ADDENDUM NO. 04

Date of Issuance: January 7, 2025

Project: **2024 Jersey Village High School Renovation**
 Cypress-Fairbanks Independent School District

Texas Arcadis Inc.
 Project No.: 202319

2 AREA 'J1' - WEIGHT ROOM FLOOR PATTERN
1/8" = 1'-0"

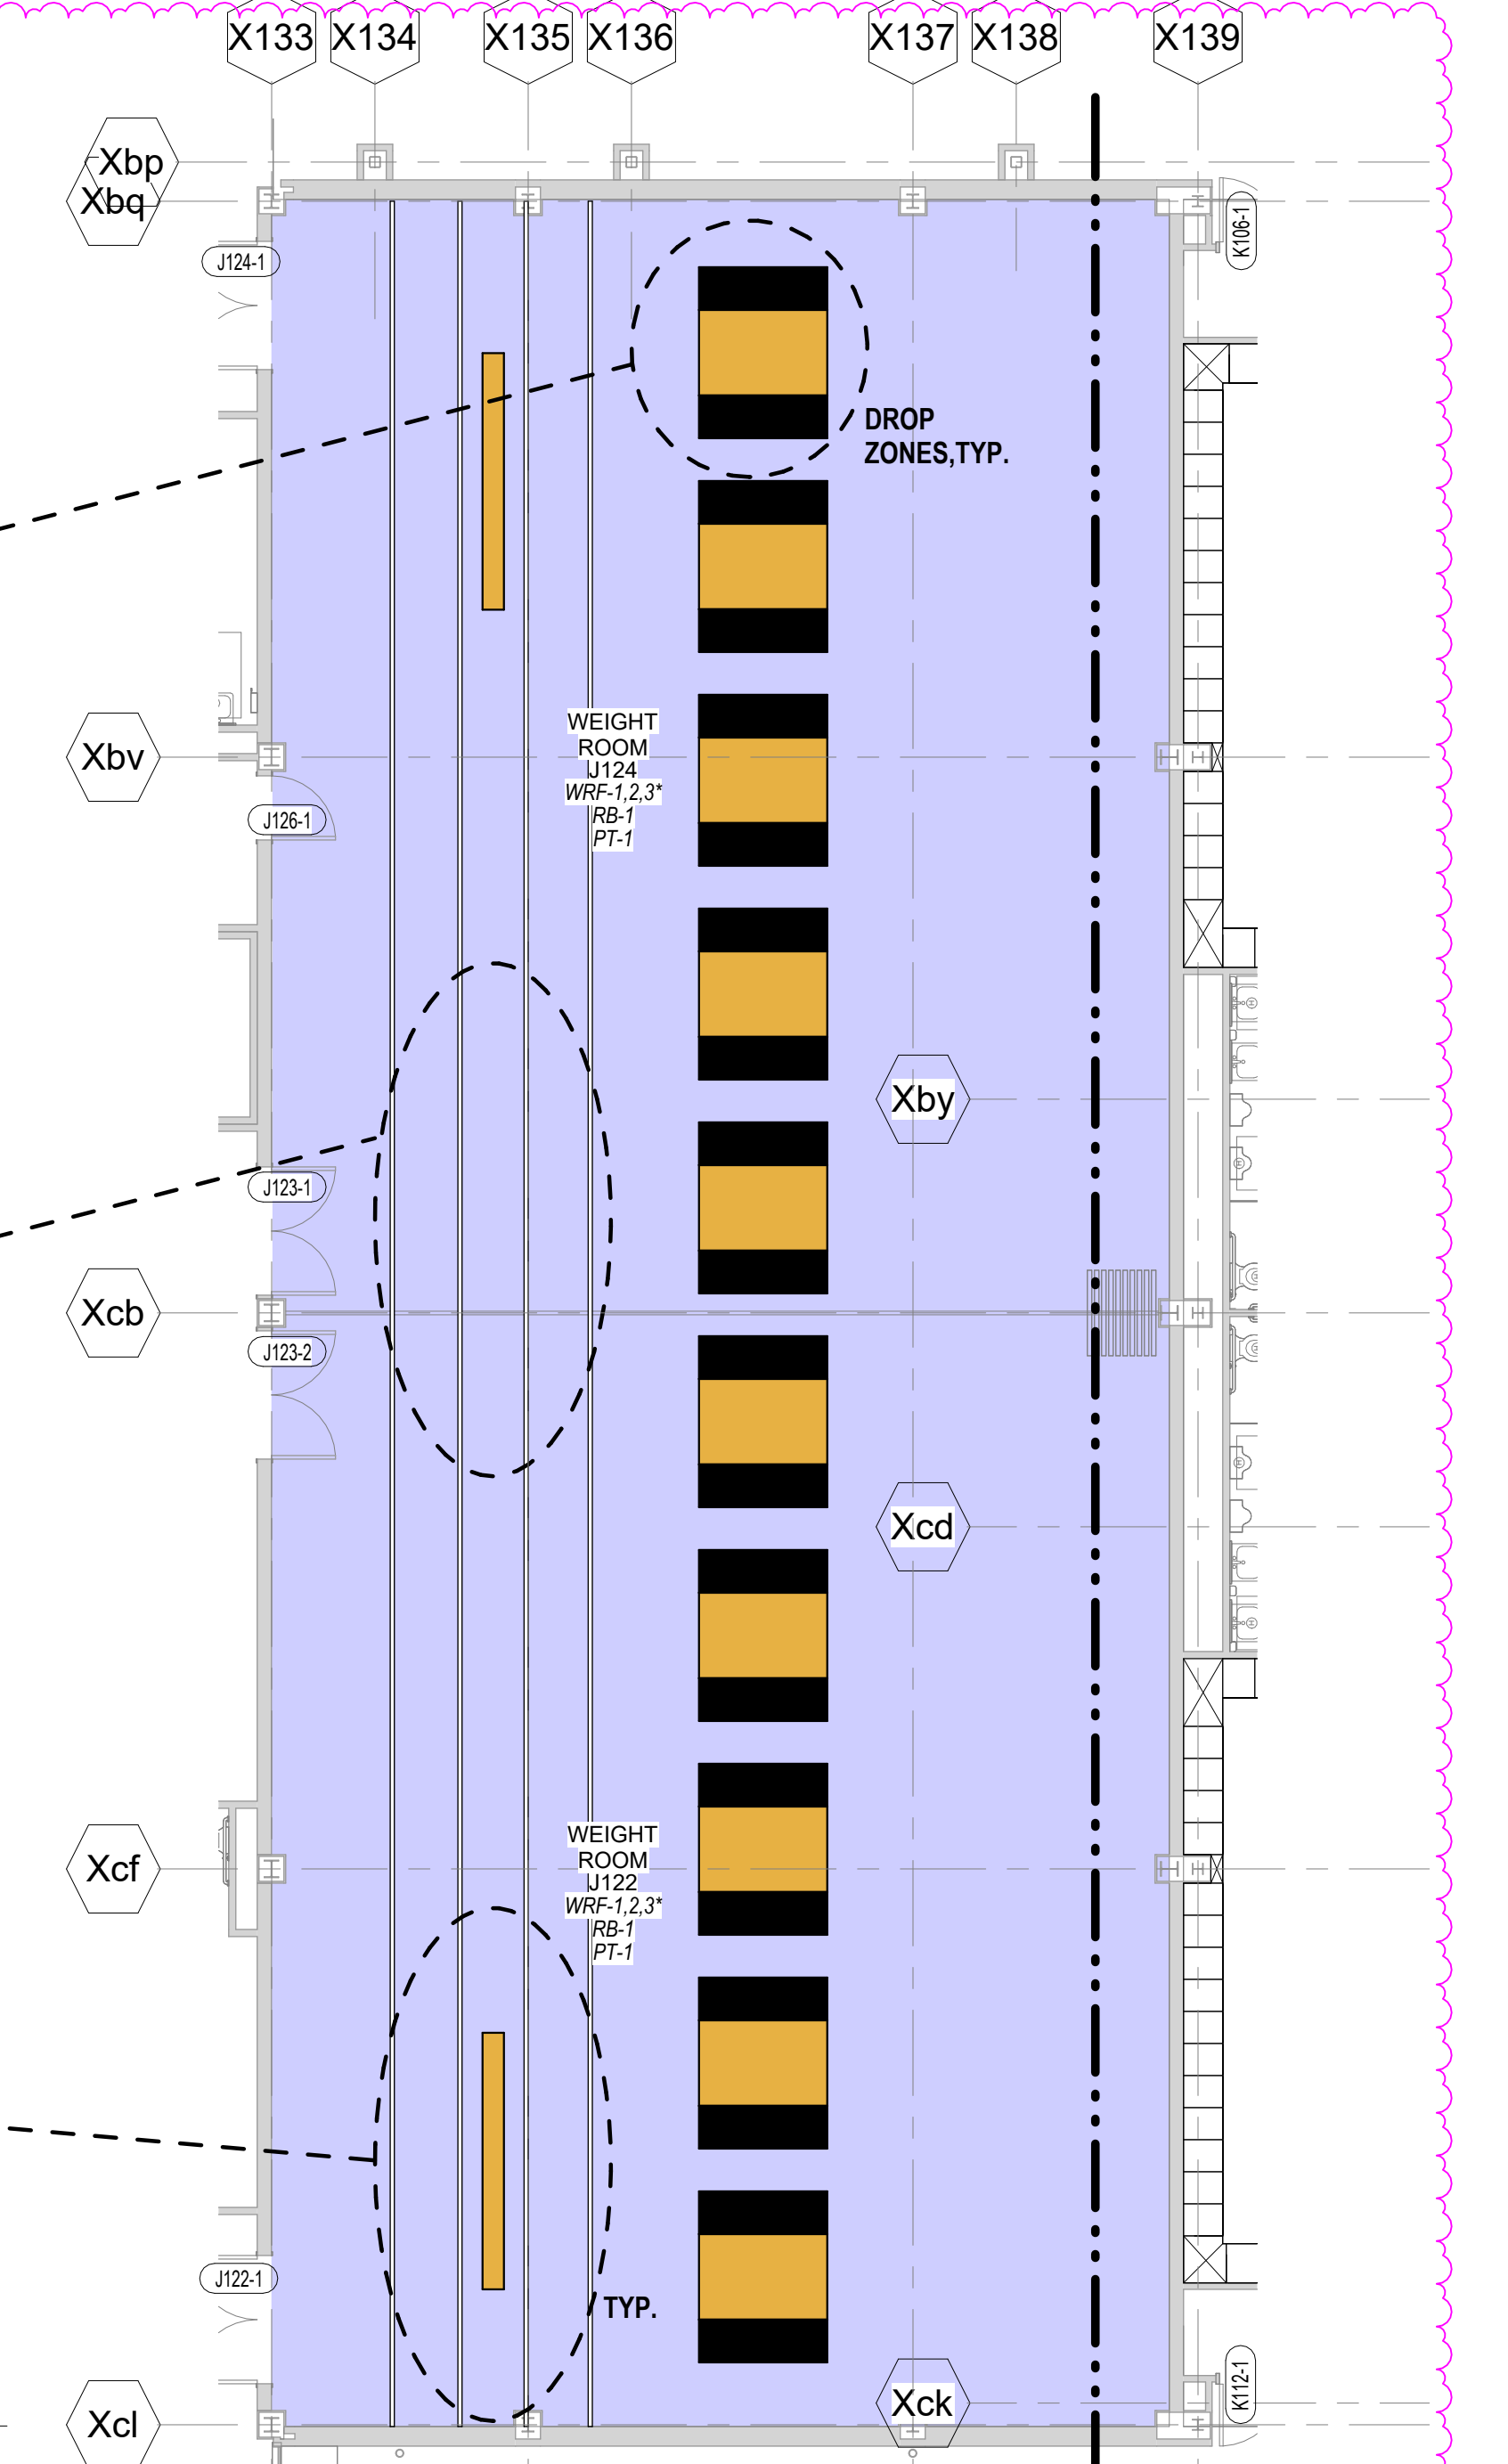
37. Sheet A11.26 – Auxiliary Gym and Weight Room Floor Pattern
 - a. Add Weight Room floor finish pattern per reissued sheet.
38. Sheet A11.27 – 2nd Floor Corridors – Carpet Pattern

A11.27
 2ND FLOOR CORRIDORS - CARPET PATTERN

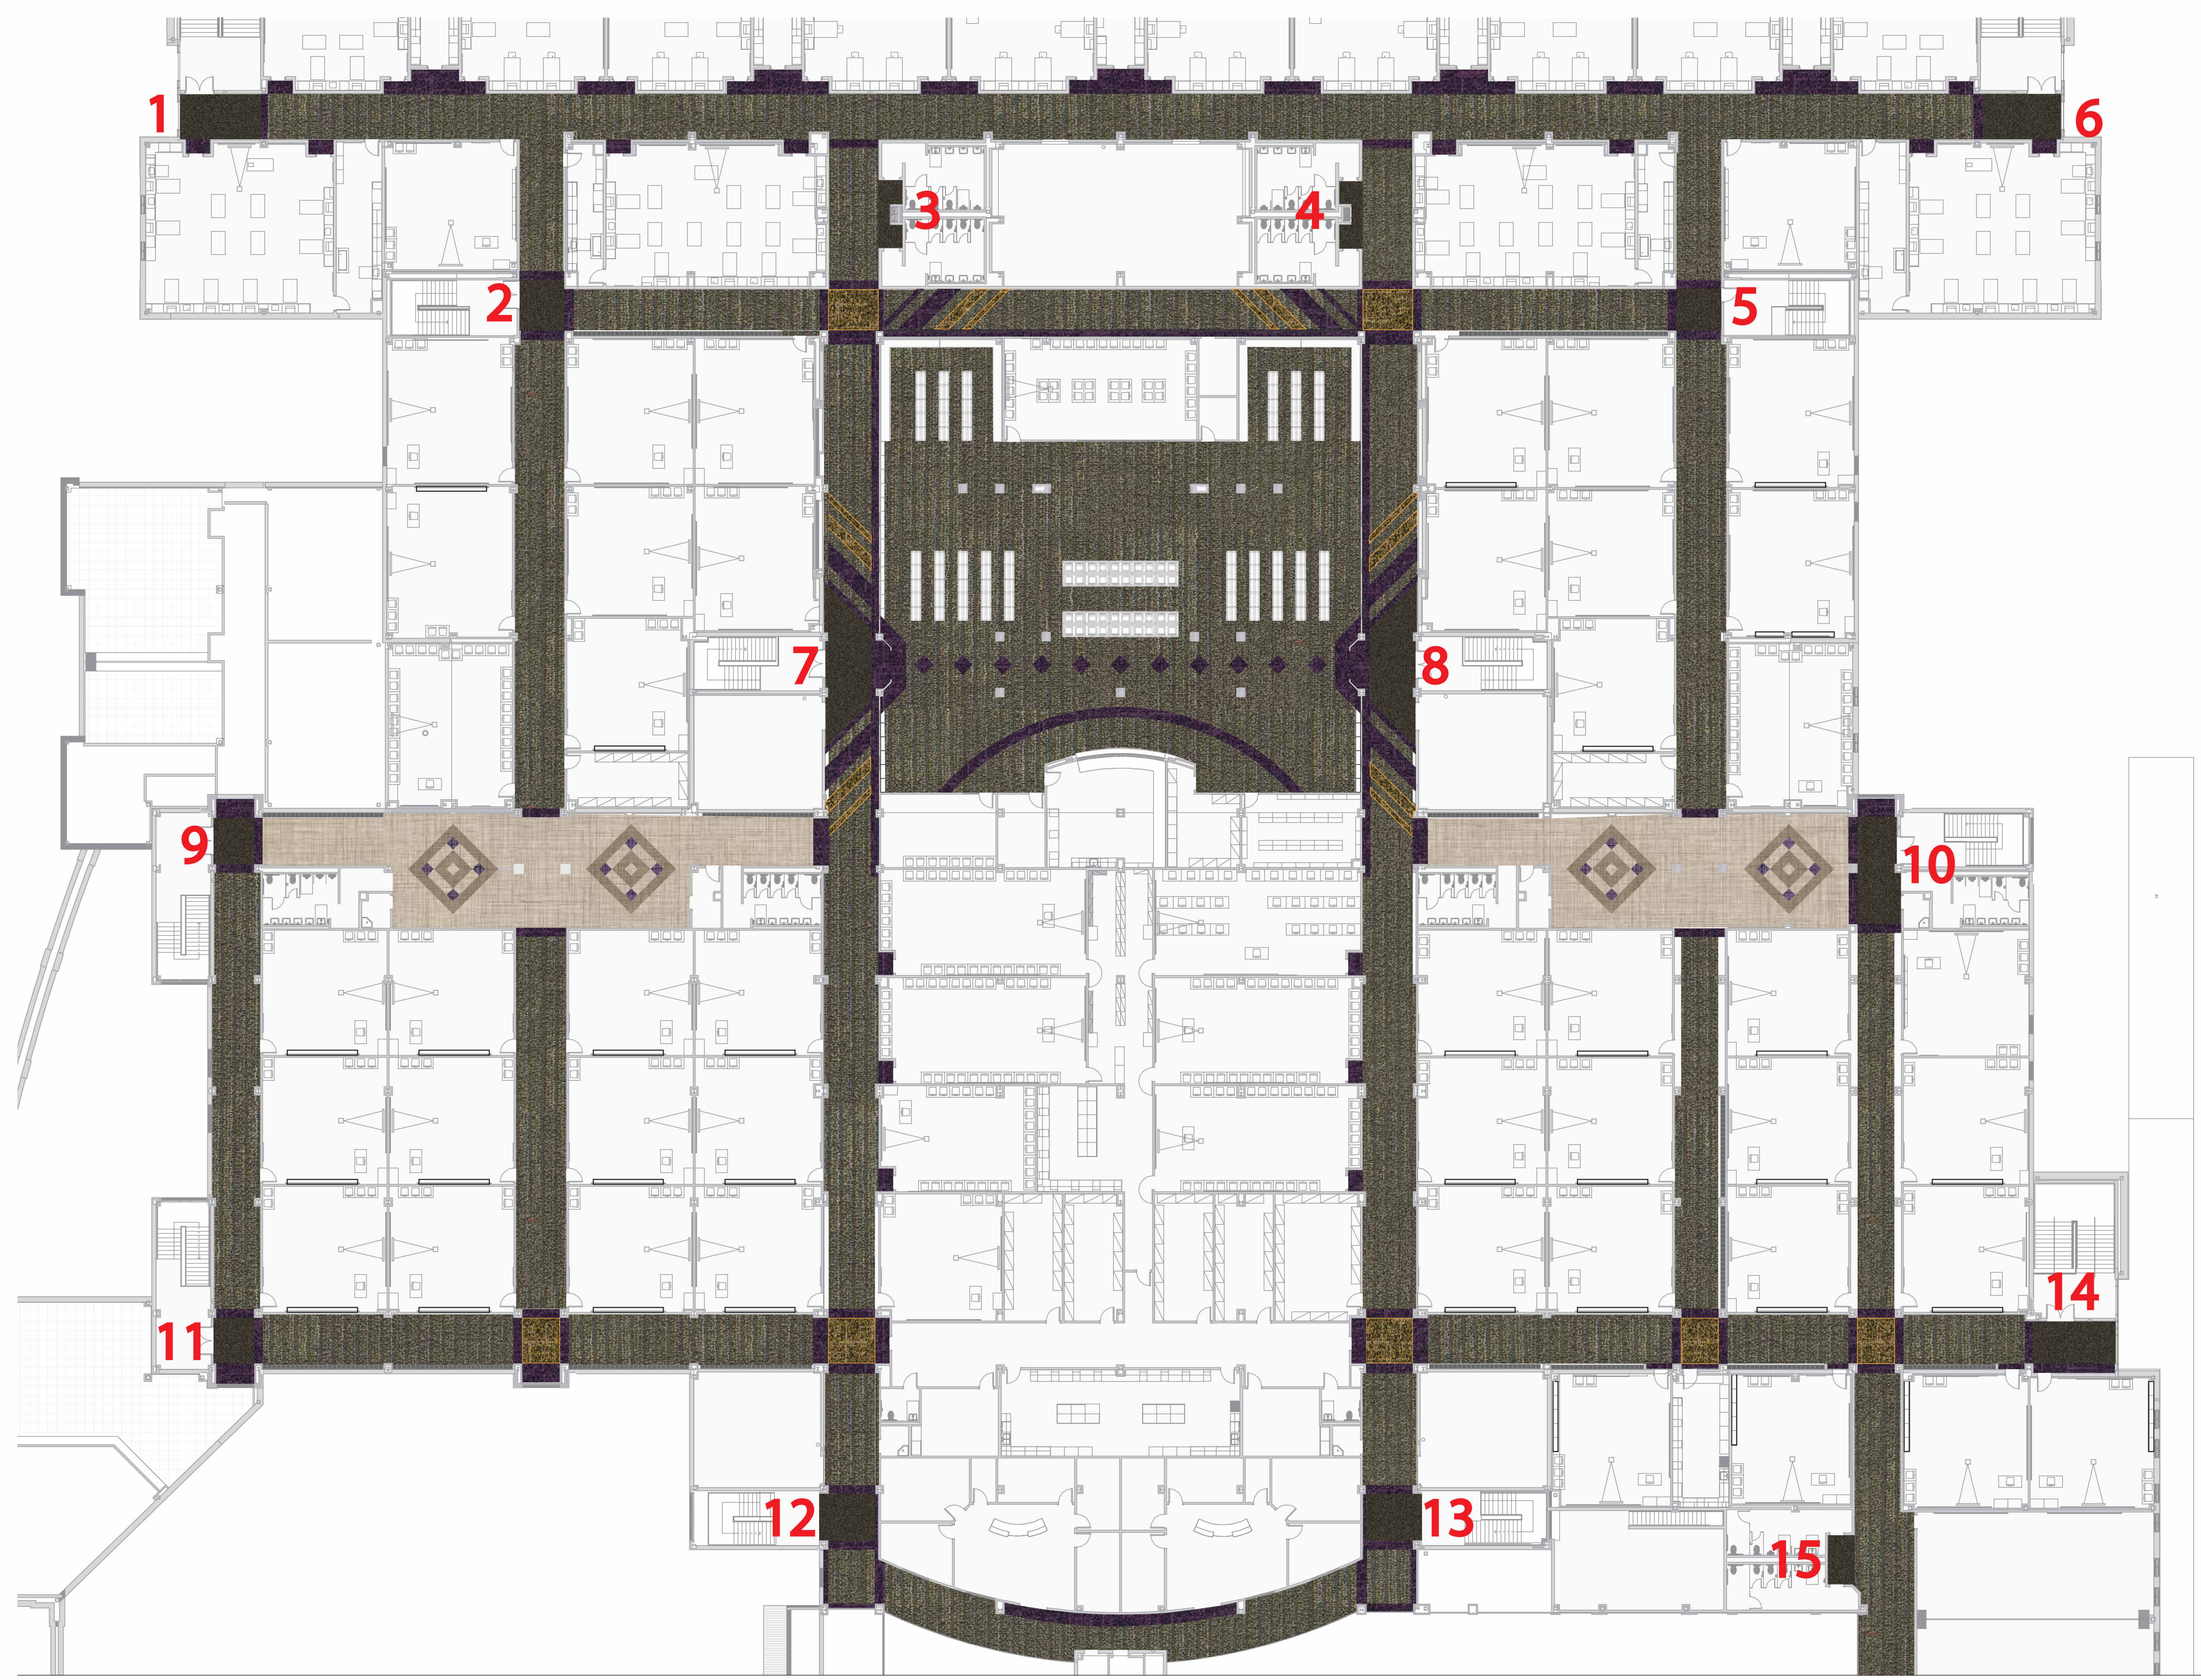
- a. Update image resolution of carpet pattern with finish legend per reissued sheet
39. Sheet A11.28 – AREA ‘F2’ – Floor Pattern Details – Multi Floors
